**BOARD ACTION REPORT – APPEALABLE ITEM**

**Project Name:** 314 NE 3rd Ave

## SITE PLAN REVIEW AND APPEARANCE BOARD STAFF REPORT

Meeting	File No.	Application Type
July 27, 2022	2022-074-SPM-SPR-CLIII	Class III Site Plan Modification
Property Owner	Applicant	Agent
Ocean Parker Delray LLC	Ocean Parker Delray LLC	Jeffrey A. Costello, AICP, FRA-RA

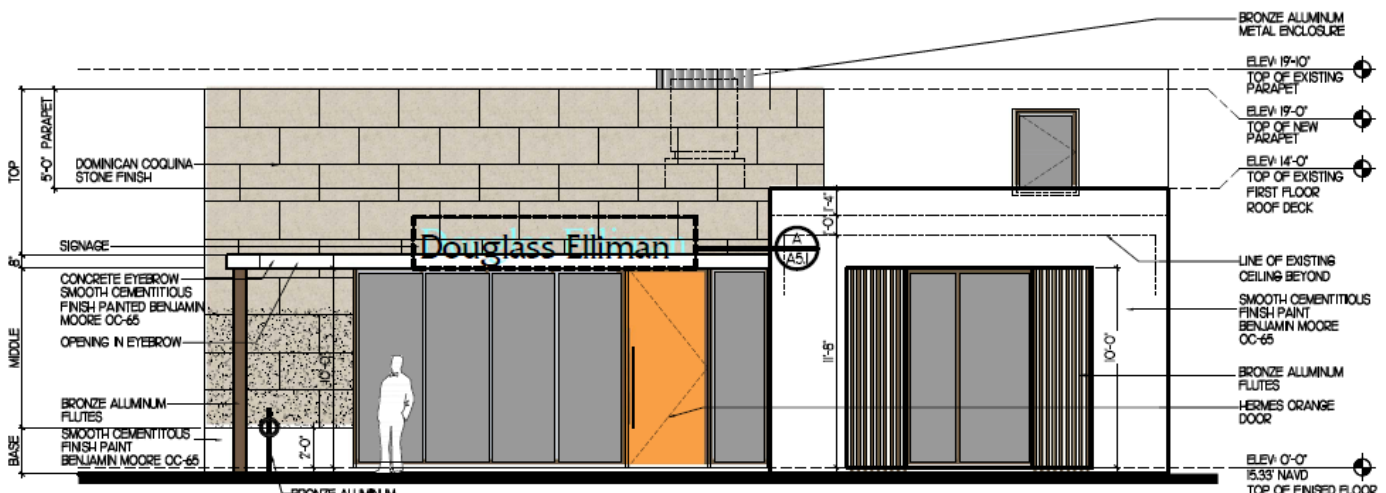
Pursuant to **LDR Section 4.6.16(H)(3)(d)**, a landscaped barrier shall be provided between the off-street parking area or other vehicular use area and abutting properties. The landscape barrier may be two feet at the time of planting and achieve and be maintained at not less than three nor greater than six feet in height to form a continuous screen between the off-street parking area or vehicular use area and such abutting property. This landscape barrier shall be located between the common lot line and the off-street parking area or other vehicular use area in a planting strip of not less than five feet in width that is free of any vehicular encroachment, including car overhang.

A waiver has been requested to provide a 3-foot, one-inch planting strip where a minimum 5-foot planting strip is required along the southern interior property line between the proposed off-street ADA parking space and adjacent property.

If approved, the waiver is not anticipated to adversely affect the neighboring area or create an unsafe situation. Landscape buffering is still proposed to the maximum degree feasible given the limited space. The waiver will not diminish the provision of public facilities as access to the alley is adequately maintained and the waiver is requested to facilitate the inclusion of an ADA parking space, which is an amenity to those members of the public that may visit the subject property but are unable to find adequate parking elsewhere within a reasonable proximity. The waiver would not grant a special privilege as the request is not being made in order to accommodate minimum required parking. Likewise, any reduced visual screening that may result from the waiver is far less impactful given that it is located back of house adjacent to a service alley where it is common to find existing properties with the entirety of the rear setback adjacent to the alley paved with hardscape.
